ADA Curb Ramp New Construction Inspection Form (Parallel)

Glencoe

24952.54

Cottage

PARALLEL RAMP (PL)

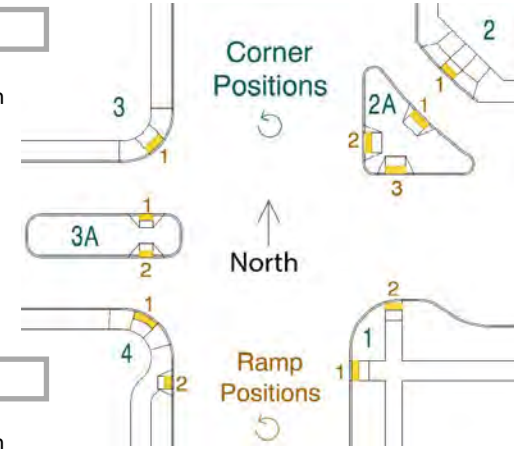
\leq 2.0% ☐ $>$ 2.0% ☒

☐ \leq 8.3% ☐ $>$ 8.3% ☒

\leq 2.0% ☐ $>$ 2.0% ☒

IITD,grater than2" behind curb
